SERVICE LETTER 74

Removal of Horizontal Panel and Trunion on 13000 Seaplane Floats for Weight Reduction

Aircraft Makes/Model(s):	Float Model(s):	Compliance: Optional	By: MAS
DeHavilland DHC-6	13000S	Part Number: 1002452	Approved: DRH
		Date: 9/7/2022	Revision: C

Figure 1

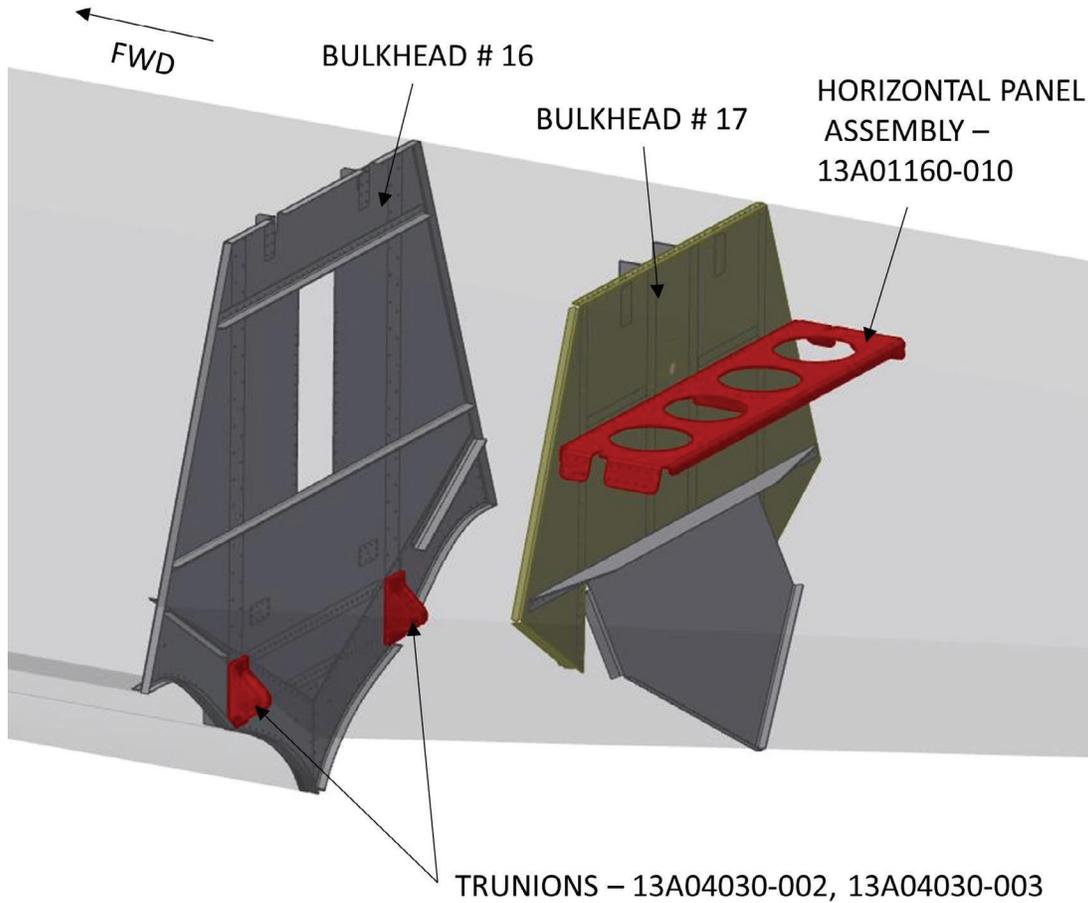
Remove all rivets that connect the horizontal panel to the #17 bulkhead. Remove the rivets that connect the horizontal panel to the side skins. Carefully break loose any sealer around the horizontal panel using a putty knife or similar scraping tool. (Be very careful not to damage the skins or the bulkhead with the scraping tools). If the float is not taken apart, you may have to cut the horizontal panel into small pieces using a cut-off wheel, so you can remove it through the top access hole. After the horizontal panel is removed, all the rivet holes on the #17 bulkhead and the rivet holes on the side skin must be filled with rivets to plug the holes. When this is completed, make sure to water check the compartments involved to make sure there are no leaks. (This is very important).

Remove the 8 bolts on the trunnions. Break loose the sealer from around the trunion using a putty knife or similar scraping tool. (Be careful not to damage the bulkhead with the scraping tool. Remove the trunnions. Plug bolt holes with bolts. (Make sure to seal the bolts by dipping them in sealer before installing them). When this is completed, make sure to water check the compartments involved to make sure there are no leaks. (This is very important).
